BOARD OF WATER SUPPLY

May 27, 2016

Subject: Board of Water Supply (BWS) Comments to the Work Plans Being Developed Under the Red Hill Bulk Fuel Storage Facility Administrative Order on Consent (AOC) Statement of Work (SOW) Sections 2 through 5 and 8

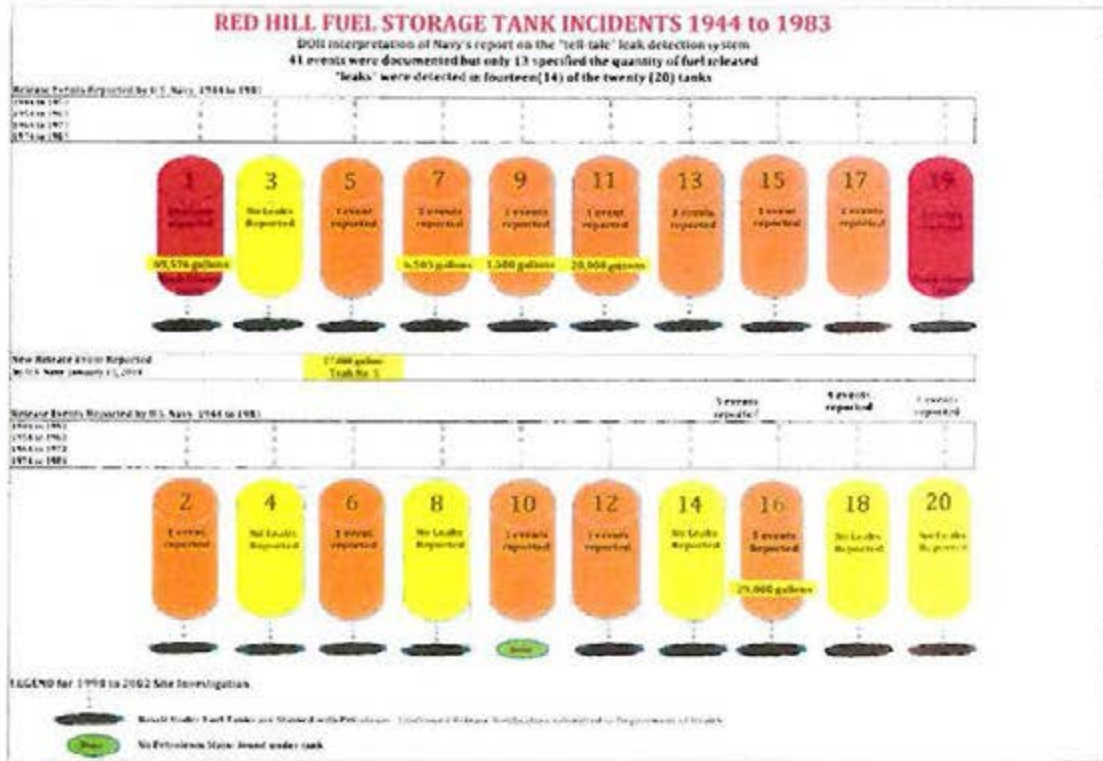
Provide a table that lists what is known about prior leaks. The Hawaii Department of Health's (DOH) chart shown below provides a basis for what should be included.
